Energize Eastside Project

Final Environmental Impact Statement

Phase 2 Draft EIS Comments and Responses

MARCH 2018

OO1-F-7

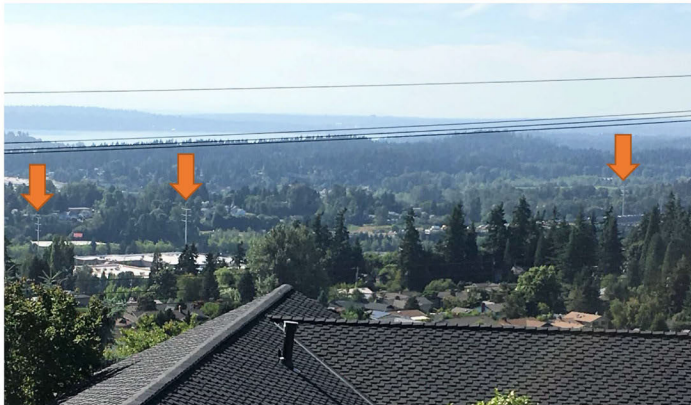
Power poles are also visible at distances greater than ¼ mile. Here is a photo taken near the Somerset Rec Club. The visible man-made structures include some roofs, nearby transmission lines, and the Seattle City Light power poles. The latter are noticeable against the background even 1 mile away:

It is true that the project could be seen at distances greater than a quarter mile. Given that the proposed location would be in an area that is generally well-vegetated, developed, and has varying topography, the views where this project would still be noticeable are few. This was confirmed by desktop analysis, site visits, and GIS analysis. For example, one simulation (see Figure 4.2-8 in the Final EIS) is taken from just beyond a quarter mile away, and visibility of the line is limited (not producing significant aesthetic impacts). A quarter mile was selected because that is where it is most likely to have significant adverse impacts. In the screenshots provided in the comment, the line is visible, but not a defining feature. It blends with the surrounding development. Furthermore, the project would not create new "notches" in the treeline as shown, because it would use an existing corridor. The mere visibility of the project does not constitute a significant impact. Simulations from Downtown Bellevue were not created because it is outside the quarter-mile study area; no specific location was identified in the comment where impacts could be significant. There would be enough visual separation between the project and Downtown Bellevue that the project would not result in significant adverse impacts.

Figure 1 PSE's Electrocution Zone

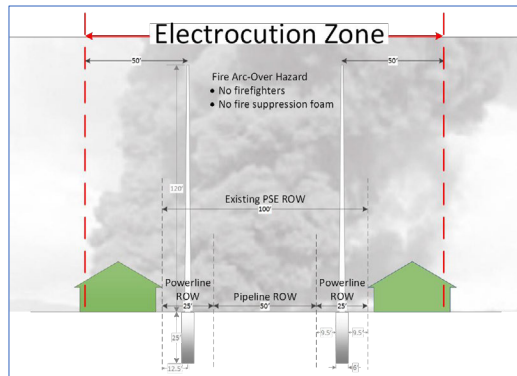
Foam is the one and only effective way to suppress a petroleum fire. But since foam is conductive, the mere presence of a PSE collocated 230 kilovolt transmission line prevents any viable attempt at safely suppressing a pipeline fire. As shown in Figure 1, the PSE collocated 230 kilovolt transmission lines straddling the pipeline creates an electrocution zone of death extending 50 feet from the 230 kilovolt transmission lines and supporting structures. When a catastrophic rupture of the hazardous liquid (petroleum) pipeline occurs, PSE's collocated 230 kilovolt transmission line could prevent any subsequent disaster recovery.

Figure 2 PSE’s accelerated corrosion of the hazardous liquid pipeline at a coating flaw

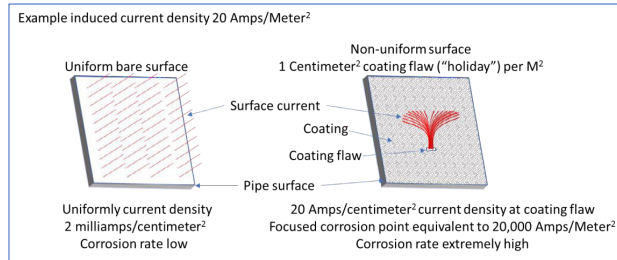
meter, one square centimeter coating flaw per square meter of surface would result in a localized current density equivalent to 20,000 Amps per square meter at each coating flaw as shown in Figure 2. This concentration of current density at a coating flaw accelerates the rate of corrosion through the hazardous liquid pipeline wall.

Figure 3 Annual minimum ambient temperature day history

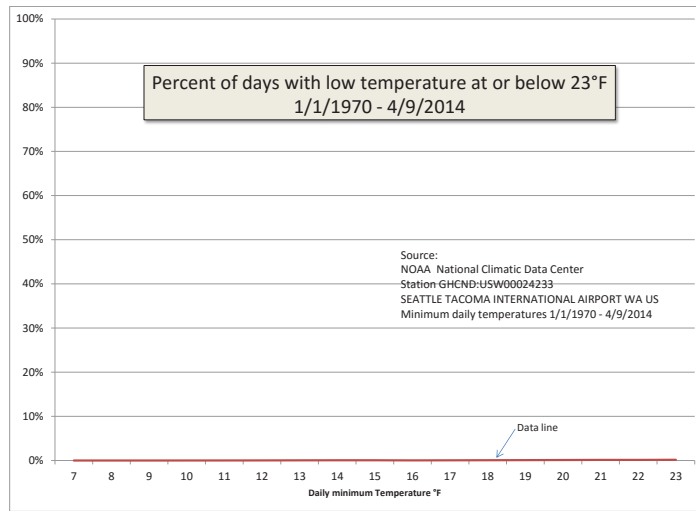
The NOAA National Climatic Data Center has a database of daily minimum temperatures for Station GHCND:USW00024233 SEATTLE TACOMA INTERNATIONAL AIRPORT WA US. Figure 3 is a summary of 16170 daily minimum temperature measurements in a period between January 1, 1970 and April 9, 2014. The horizontal scale is the daily minimum temperature in one-degree Fahrenheit increments from the lowest measured value in the period (7°F) to 23°F. The vertical scale ranges from 0% to 100% and is the percentage of the period in which each minimum temperature was recorded.

I1122-A-57

Figure 4 Annual minimum ambient temperature day history - Expanded view

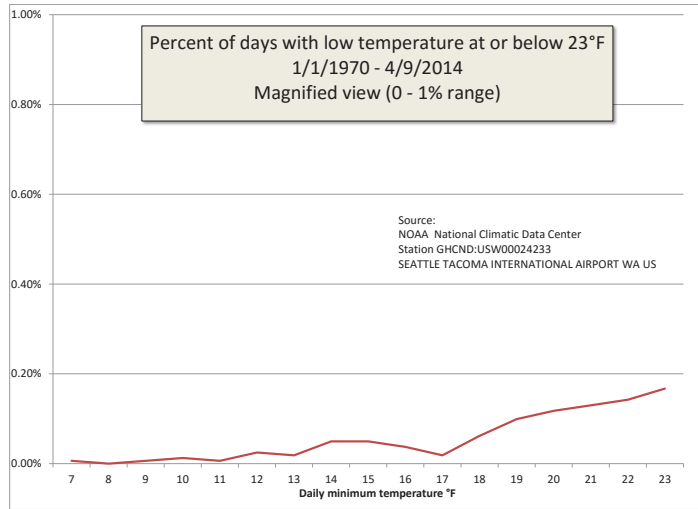
Since the occurrences of 23°F and lower temperatures days are extremely infrequent an expanded view of the bottom 1% is provided in Figure 4.

I1122-A-57

Figure 5 PSE's solution versus stated need in perspective

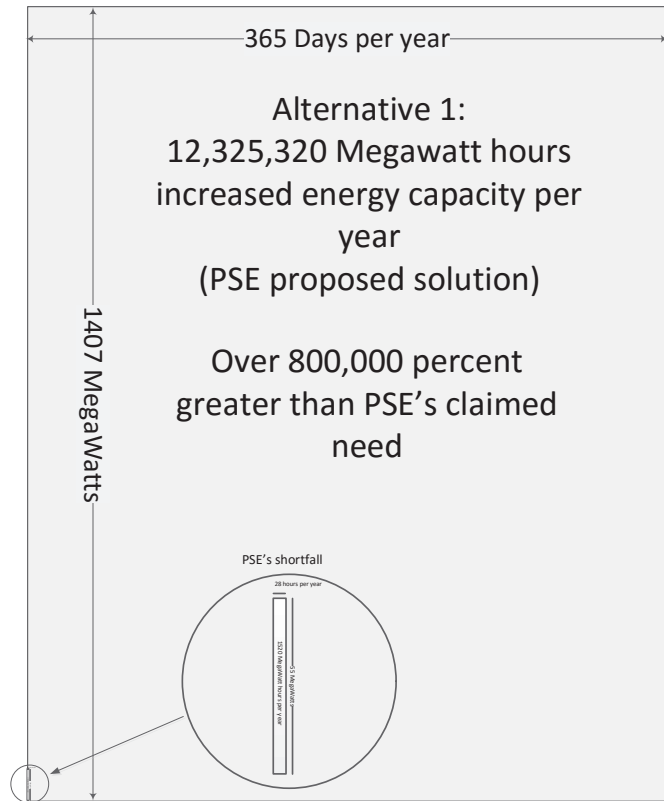
Figure 5 shows the relative scale of PSE’s proposed project versus PSE’s statement of need during the CAG process. To be clear, the percent increase in capacity vs need as stated above is over 800,000 percent. An increase of this magnitude will never ever be needed in the PSE customer base area.

I1122-A-58

Figure 5

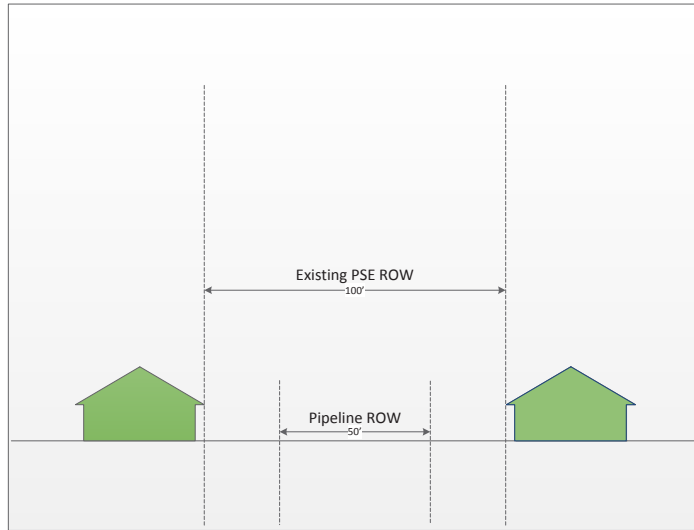
Figure 5 is a diagram of the current PSE power line Right Of Way (ROW) and the Olympic Pipeline Hazardous Liquid Pipeline ROW through the Olympus residential community in Newcastle. This is a segment of the proposed route ‘M’. The hazardous liquids consist of highly flammable petroleum products (kerosene, jet fuel, diesel fuel, and gasoline). The liquid is pumped at very high pressure

(approximately 1400 pounds per square inch) through two pipelines within the pipeline ROW. In the Olympus neighborhood, the hazardous liquid pipeline ROW is 50 feet wide and centered within the 100 foot wide PSE power line ROW.

Figure 6

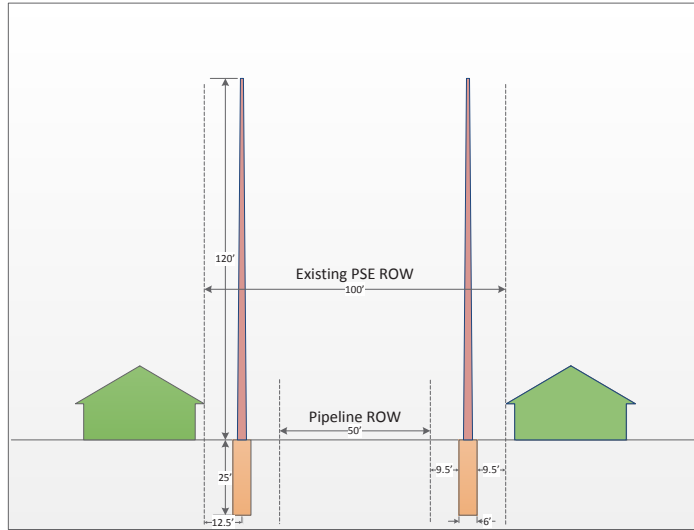
Figure 6 shows the nominal location of 120 foot tall monopole towers on 6 foot diameter footings to support the proposed 230kV lines. The footings must be placed in undisturbed soil to be able to withstand lateral forces on the monopole. A minimum margin of undisturbed soil around the footing is required and must be within the PSE power line ROW. As can be seen, the footings can only be located within the outer 25 foot margins of the 100 foot wide PSE power line ROW without directly violating the hazardous liquid pipeline ROW. The edge of the footing is potentially within 9.5 feet of existing and future residential structures given the current 100 foot wide easement. This is far too narrow.

Figure 7

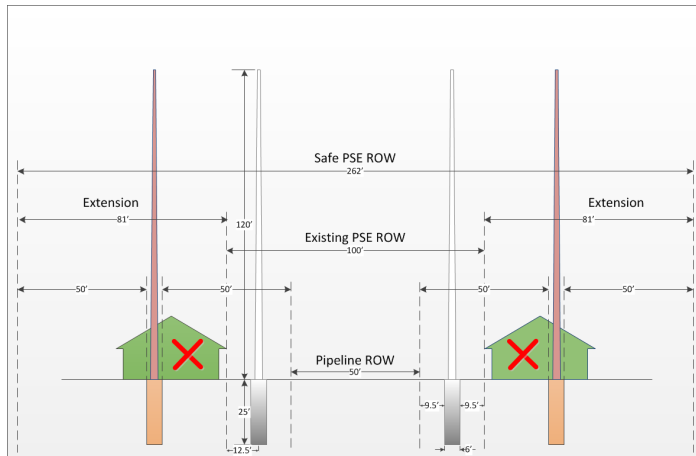
Figure 7 shows the proper extent of a 230kV power line ROW adjacent to a pipeline consistent with BPA standards. Although not as rigorous as other U.S electrical power industry standards it does present a moderate safety solution. As can be seen, the existing ROW has insufficient width to accommodate the proposed 230kV power line. Clearly, the application of common sense modern standards precludes the routing of the 230kV power line through route 'M' within the existing corridor.

Figure 3.9-7. Typical Pool Fire and Heat Flux Areas Diagram

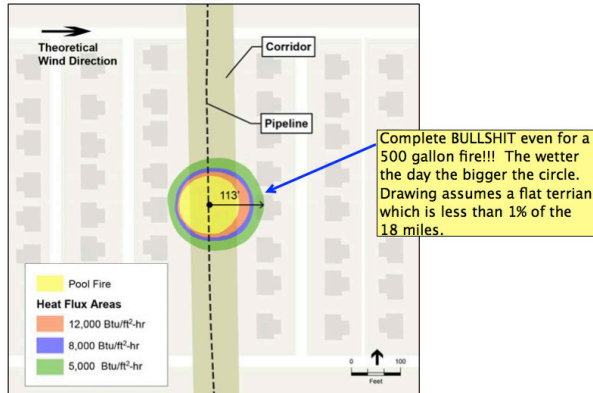
Please expand and inform the societal risk section of the EE EIS with pipeline and power line location rules relative to schools for Texas to those in WA. Texas the seat of the criminal fossil fuel industry, has a quite more restrictive take. What does Texas do and what are its societal risk analysis numbers?
